**RE: 69-77 OLD PUB LANE, GREENBANK
TRAFFIC ENGINEERING ASSESSMENT**

This report has been amended by PTT, in response to a Further Issues Letter from Economic Development Queensland (EDQ), dated 13 February 2025. The updated report responds to Items 7-14 of the Further Issues Letter (reference: DEV2024/1576), which relate to parking design and on-site manoeuvring.

**PLANS AND DOCUMENTS
referred to in the PDA
DEVELOPMENT APPROVAL**

Approval no: DEV2024/1576

SITE PLAN

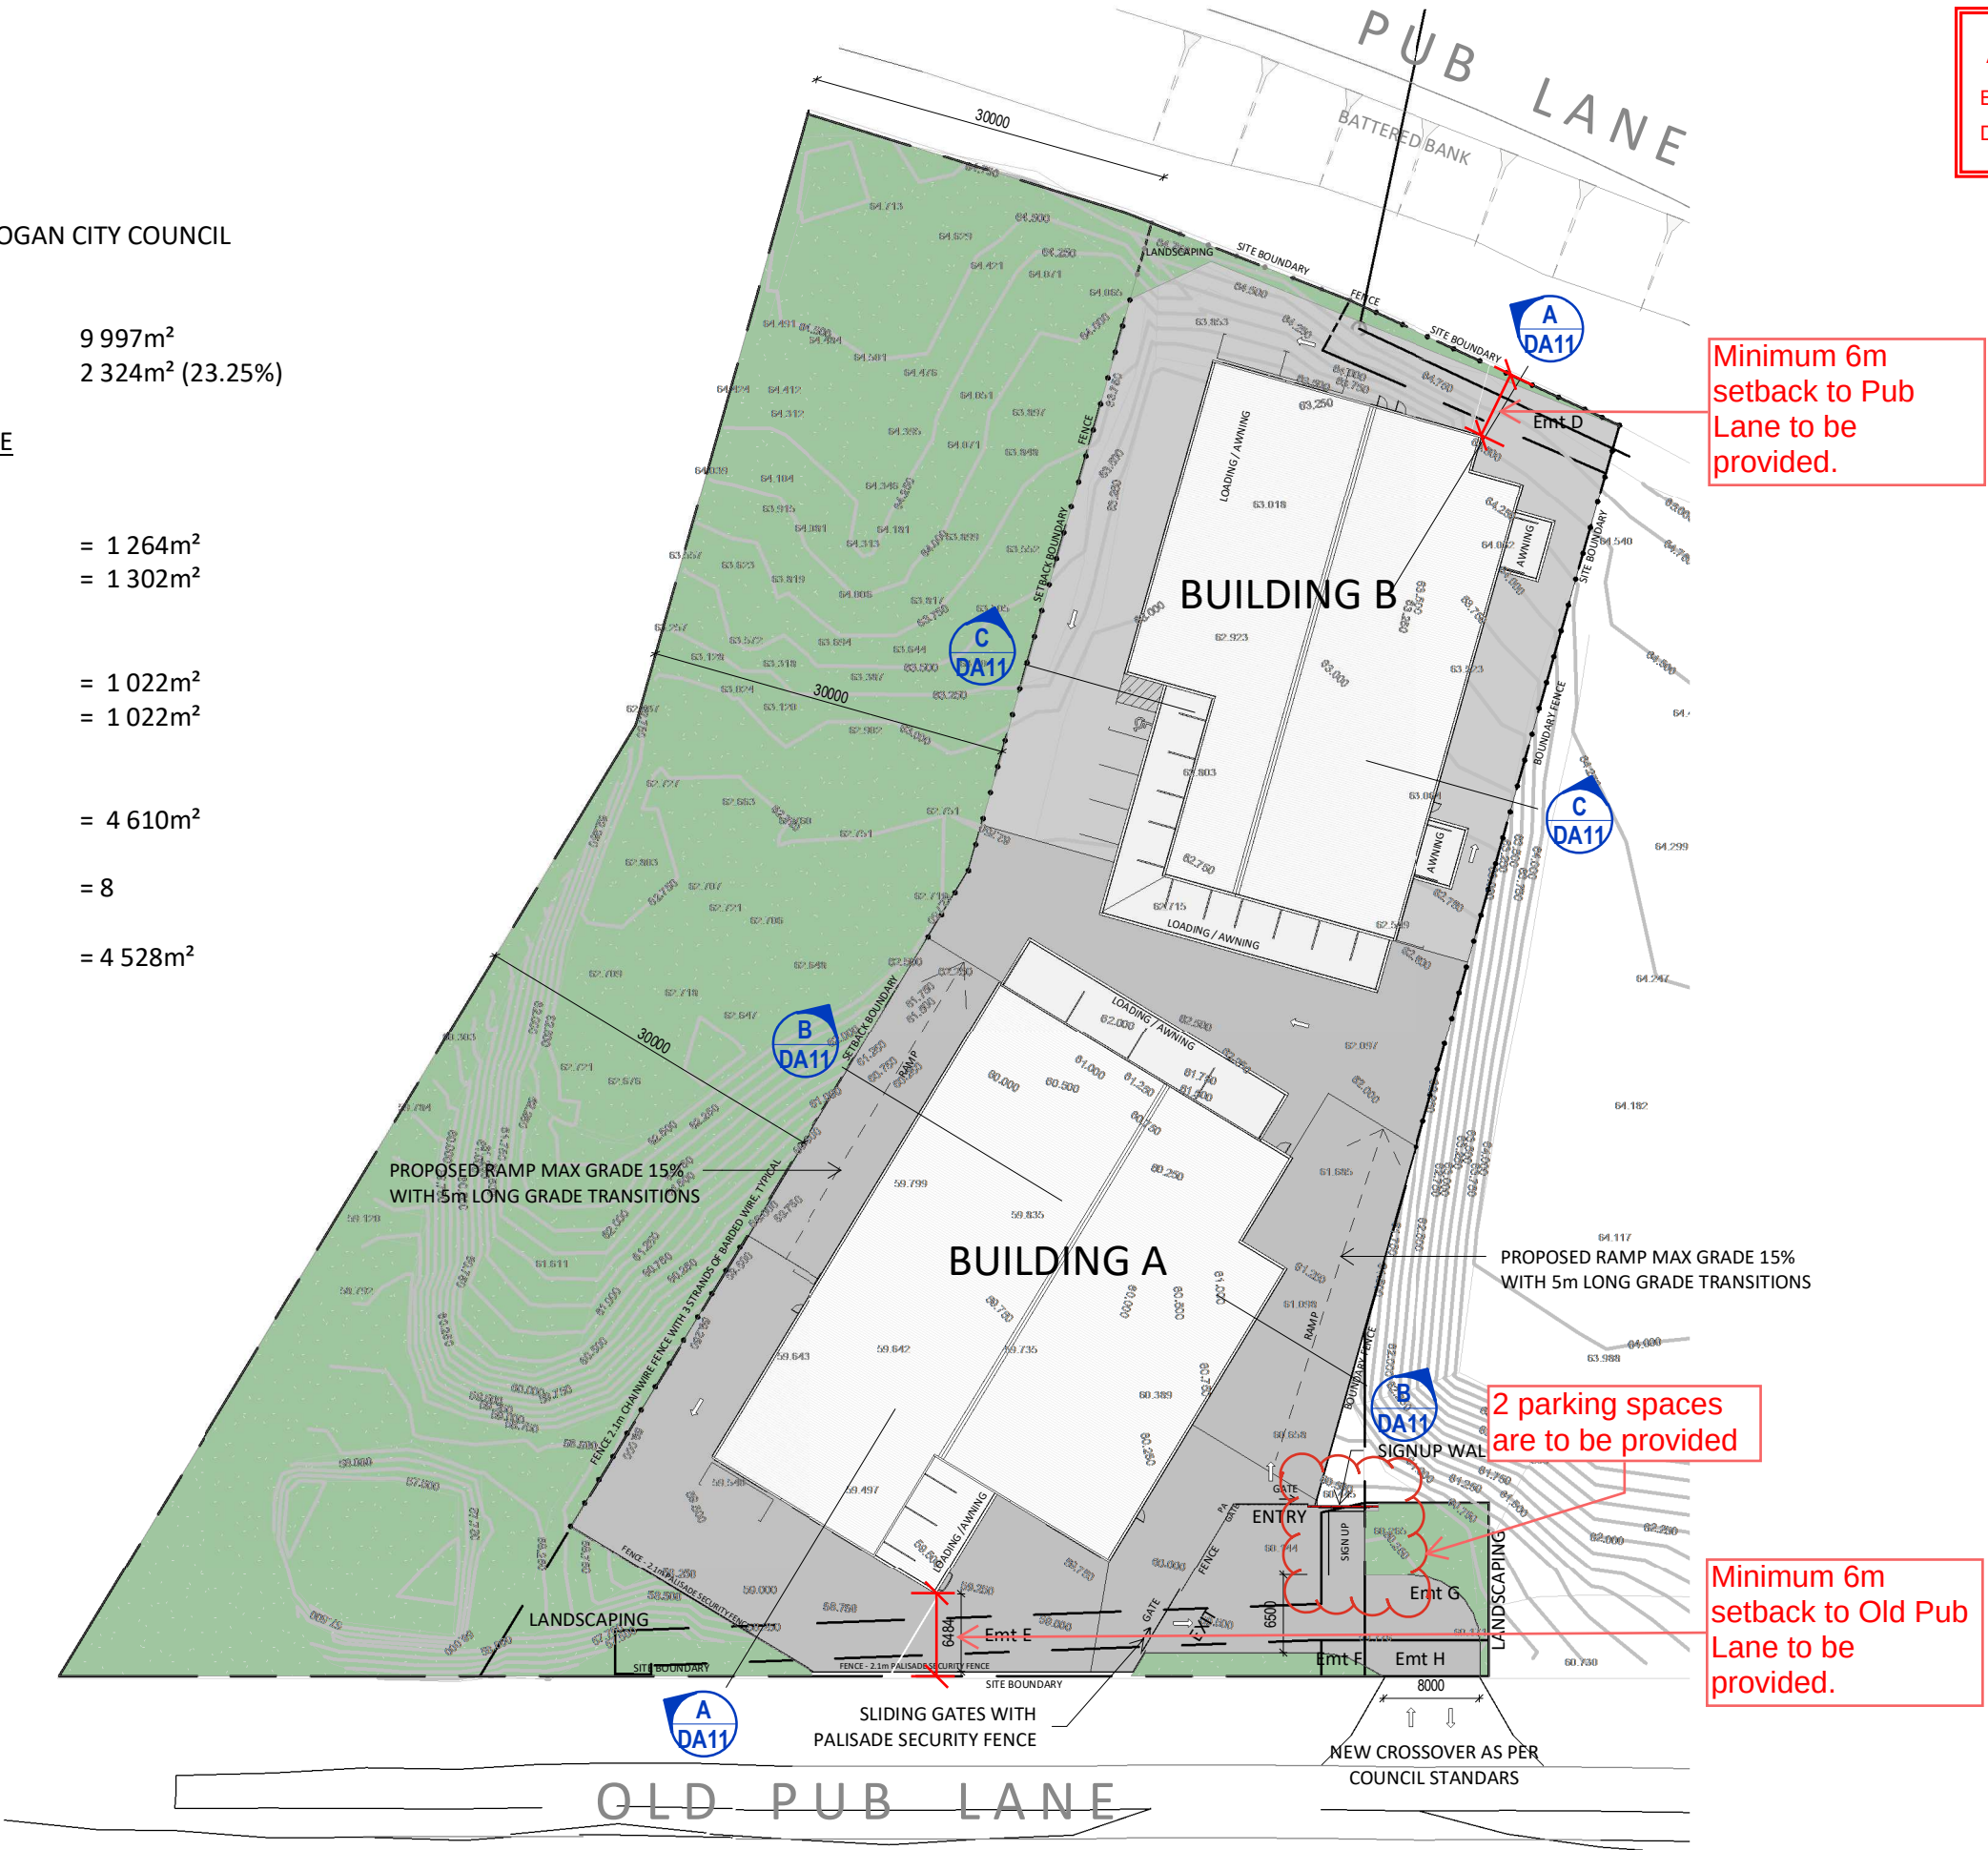
Minimum 6m
setback to Pub
Lane to be
provided.

2 parking spaces
are to be provided

Minimum 6m
setback to Old Pub
Lane to be
provided.
